GNRO-2015/00064

SUBJECT: Grand Gulf Nuclear Station Response to Electronic Request for Additional Information Regarding Modification of Technical Specification (TS) 3.8.4, "DC Sources" Operating Surveillance Requirements (SRs) 3.8.4.2 and 3.8.4.5 Amendment Request, dated August 28, 2015.
Grand Gulf Nuclear Station, Unit 1
Docket No. 50-416
License No. NPF-29

Grand Gulf Nuclear Station Response to Electronic Request for Additional Information Regarding Modification of Technical Specification (TS) 3.8.4, "DC Sources" Operating Surveillance Requirements (SRs) 3.8.4.2 and 3.8.4.5

Figure 1 Intercell Resistance measurement

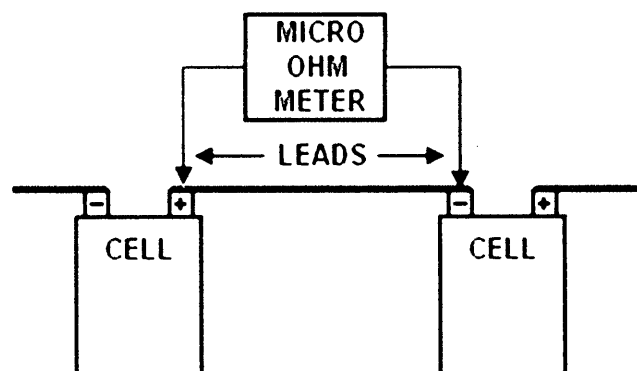
Based on the clarification provided in the conference call and the guidance provided in Attachment 2, "Surveillance Procedure [SP] 06-EL-1L11-R-0001, 125 Volt Battery Bank Physical Condition Check," of the March 27, 2015 letter, the staff understands that the procedure has an administrative resistance limit of 0.5 E-4 ohm for each positive or negative post connection measured on each side of the interconnecting bars. Since the inter-cell connection resistance consists of the total resistance measured between the positive post of one battery cell and the negative post of the adjacent battery cell, with both posts interconnected by a bar (see Figure 1 below), it appears that the allowable inter-cell connection resistance for GGNS Division 1 and 2 batteries, according to SP 06-EL-1L11-R-0001 provided in Attachment 2, is $0.5 \text{ E-4 ohm} + 0.5 \text{ E-4 ohm}$ or 1.0 E-4 ohm .

Please explain:

- a) How the administrative resistance limit for each positive or negative post connection as measured in SP 06-EL-1L11-R-0001 corresponds to the proposed value for inter-cell connection resistance in the SR.
- b) How the inter-cell resistance value is considered in battery capacity calculations
- c) How the proposed inter-cell resistance for Division 3 battery is calculated
- d) How the resistances of any inter-rack cables is measured and considered in the battery capacity calculations.

Referring to Figure 1 above (page 2 of 4):

- a. Please also refer to page 5 of SP 06-EL-1L11-R0001. This surveillance for Division I and Division II measures resistance across each bolted connection between the cell post (Test Point "A") and the two interconnecting straps (Test Point "B") recording the highest resistance. Each cell that has interconnecting straps is tested in this manner. For Division I and Division II, the administrative limit of each positive and negative connection, with the exception of the battery end connection and cell 30 to cell 31 connection, is 100 micro-ohms. Resulting, the maximum allowed "intercell connection resistance" would be the sum of the post-to-strap allowed connection resistances, or 200 micro-ohms.

- b. The resistances are incorporated in calculations EC-Q1L21-90033, EC-Q1L21-90046, and EC-Q1L21-90023 by the bolted connection resistances as described in the 2.a. response in this RAI, not as the "intercell connection resistance". To clarify, the values are incorporated in the manner that the surveillance is executed in that the resistance is incorporated based on terminal connections. How this resistance is calculated and incorporated into each calculation is discussed in section 3.3 of EC-Q1L21-90033 and EC-Q1L21-90046, and section 3.4 in EC-Q1L21-90023. The calculations are provided in response to RAI #3.

- c. Please also refer to page 6 of SP 06-EL-1L11-R0001. This surveillance for Division III measures resistance across each bolted terminal connection between the cell post flag (Test Point "A") and the intercell strap (Test Point "B") and records the measured resistance. Each positive and negative terminal connector is measured in this manner with an administrative limit of 100 micro-ohms. Resulting, the maximum allowed "intercell connection resistance" would be the sum of the measurements, or 200 micro-ohms.

- d. Please refer to page 5 of SP 06-EL-1L11-R-0001. Step two refers to the process of measuring resistance for the inter rack connection. Each connection is administratively restricted to 100 micro-ohms, summing to 200 micro-ohms for the inter rack connection. How this resistance is calculated and incorporated into each calculation is discussed in section 3.3 of EC-Q1L21-90033 and EC-Q1L21-90046. The calculations are provided in response to RAI #3.
